INDESIT company

Model type:
WIL85XEX

Commercial code:
F030529

N1040319FIG1

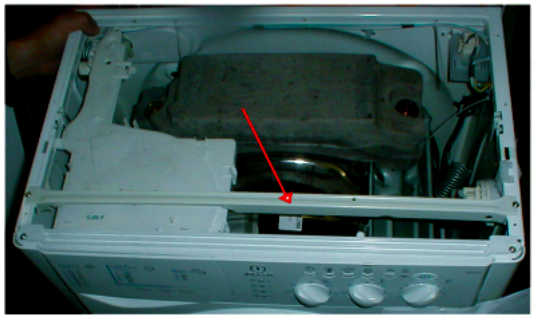
n1040319: Elimination of metal bar on INDESIT cabinets.

From serial no. 40223.0001 Indesit EVOII Washing Machines produced in the Comunanza - Brembate factory have been equipped with a wooden reinforcing strip on the top, whereas the metal bar on the cabinet has been eliminated.

The modified tops have the same Service code as premodification items (096937, 097617, 098440, 099929 and 097806).
When using the new top on a premodification appliance the metal bar (see N1040319FIG1) must be removed, whereas the old top can be used in place of the new one without any modification.
The new top can be used in place of the old one and vice versa; the Service code remains the same.

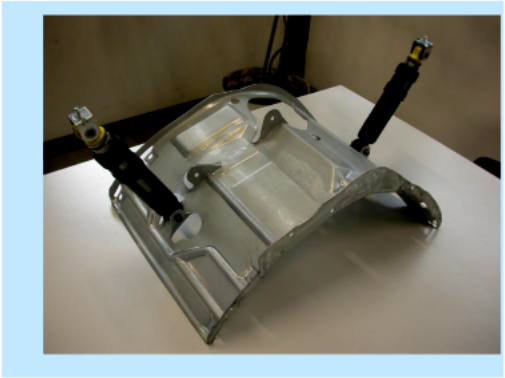
n1040325: New shock absorber fixing system with pin

From serial no. 40427.0001, shock absorbers have been fixed to the tank unit cradle with two 11 mm pins code C00110163 (see fig. 01 and 02 enclosed) in place of the 8 mm screws code 093750 and relevant locking nuts code 030443, on all washing machines and dryers produced in the Comunanza factory.
The items affected by this modification are:
1) The cradles have the same Service code, as they can be used in place of the new ones after widening the shock absorber fixing holes to a diameter of 10 mm.
Code 093848 - Tank unit cradle 46 lt
Code 093878 - Tank unit cradle 40 lt.

2) The new shock absorbers, with fixing bushing having no s/steel spacer, are not managed as they are interchangeable with the premodified items (make sure they are CIMA type, as the managed items), fixed with M8 screws code 093750 and related locking nut code 030443 (see figs. 05 and 06).
Code 093884 - Shock absorber 80 N
Code 093885 - Shock absorber 100 N

To remove the shock absorber from the tank, first extract the pin with a few hammer taps (see fig.03) until it is aligned with the tank bracket and then pull it out with a pair of pliers (see fig. 04).
(To refit the shock absorber use a new pin. Insert the pin until the toroidal edge is aligned with the bracket.)

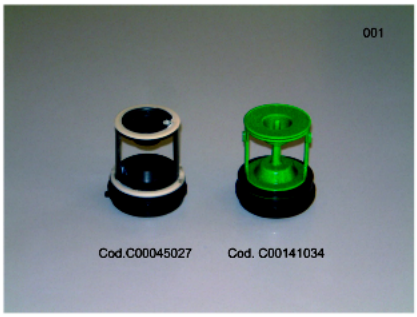
n1040359: Polar White Factory 80 (Comunanza)

From serial no. 50315.0001, the new "Polar White" colour is used on all washing machines and washer-dryers produced in factory 80 in place of White 27.
The third last number of the Industrial Code given on the rating plate of the modified models is 9 (e.g. 80286390900).
To determine the new Polar White codes, it is necessary to know the industrial code or serial number of the appliance being repaired.
The new items, which bear the initials "PW" in place of "B27", are not aesthetically interchangeable with premodification items as the whites are different. Both colours will be available for some time.
The items affected by this modification are:
Body, rear panel, top, control panel, handles, buttons, knobs, knob disc, door and plinth.
